Subject: **Review of Transbay Transit Center Design of March 9, 2010**

The Engineering Management Team (EMT) has reviewed the drawing submitted by TJPA's design consultant Parsons Corporation on March 9, 2010. While the team did not conduct a comprehensive review of proposed station configuration and alignment, they were able to focus on three major components of the design:

**CALTRAIN DOWNTOWN EXTENSION
650' RADIUS HSR TRACKS
AND PLATFORM EXTENSION STUDY**

**FIGURE 1
MARCH 9, 2010**

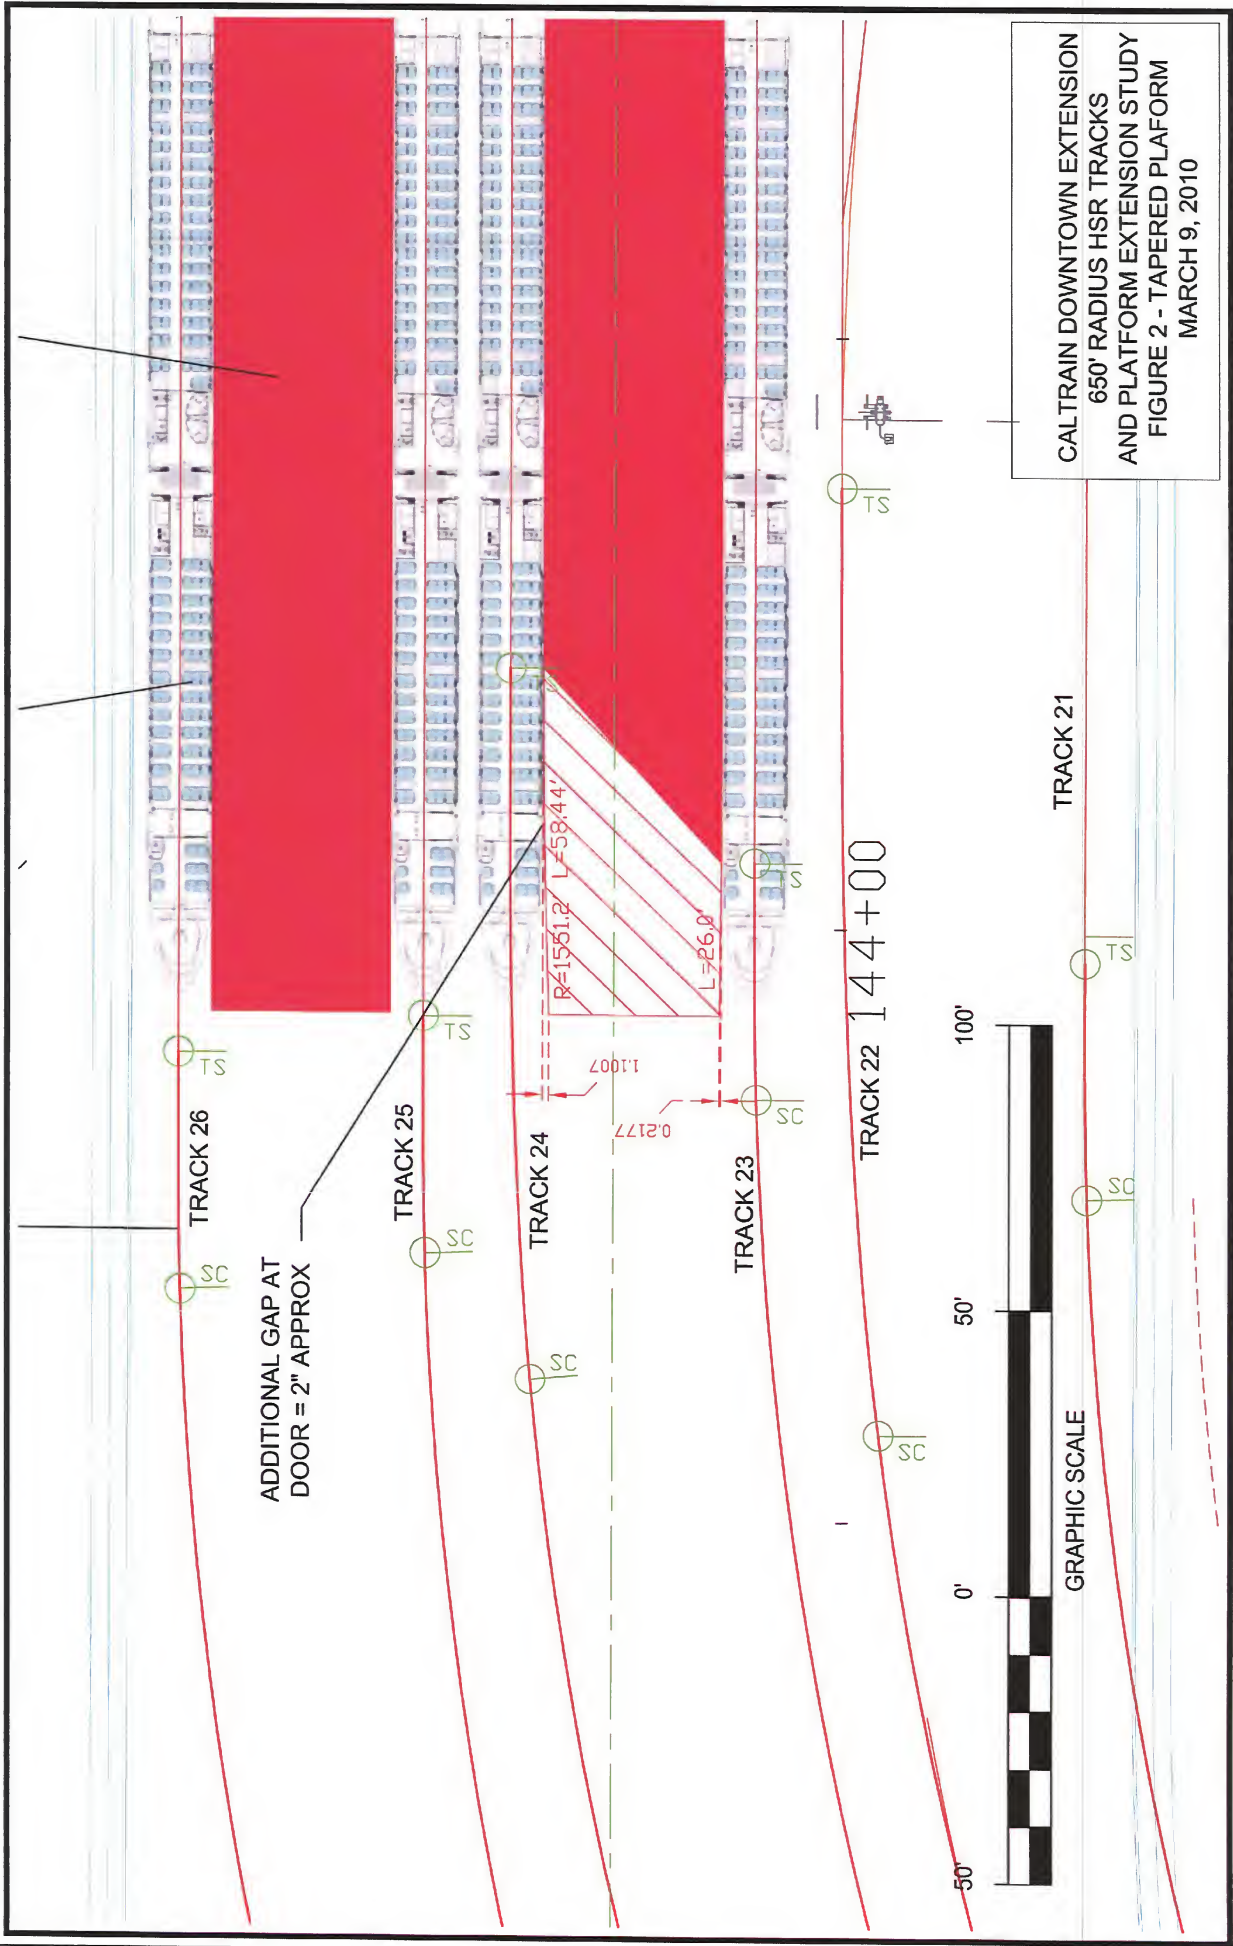
Horizontal radius of 650-foot is commensurate with the tightest radii (622-foot / 190 m) that the EMT has found in revenue service at Cologne Central Station. This will require a design variance for it to be accepted as part of the HST system.

Alignment does not provide length of tangent track (75 foot) either side of platform needed to ensure swing of the cars do not require a tapered platform. In the absence of the tangent, we assessed platform tapers is all that is required. This will also require a design variance.

In the absence of a design, the 40 foot length of track to allows for 30 feet inclusive of physical 'bumper' requirements plus a 10 foot distance from normal train parking position for end stop requirements. This 40 total distance would require a 3-5 mph operational speed.

Platforms (23, 24, 25 or 26) meet the exceptional design criteria length of 1315 feet. The 1315 foot exceptional length does not provide for the TSI (European Technical Specifications for Interoperability) tolerance that permits train length to be increased 1% for aerodynamic design. A design variance will be required for the total length of the platforms.

Platforms on tracks 23, 24, 25 and 26 will all require additional offsets due to the adjacent or proximate curves in the platform tracks. The beginning point of the need for additional car to platform clearance is based on the point at which the swing in the car body begins due to curvature, which is based on vehicle characteristics.

Track 23: 82.5 feet into the platform, maximum offset at end: 10.1 total inches or a 7.1 inch additional gap.

Track 24: 108.9 feet into the platform, maximum offset at end: 6.7 inches or a 3.7 inch additional gap.

Track 25: 56.5 feet into the platform, maximum offset at end: 4.7 inches or a 1.7 inch additional gap.

Track 26: 29.1 feet into the platform, maximum offset at end: 3.7 inches or a 0.7 inch additional gap.

A design variance would be required for the potential platform gap issues.
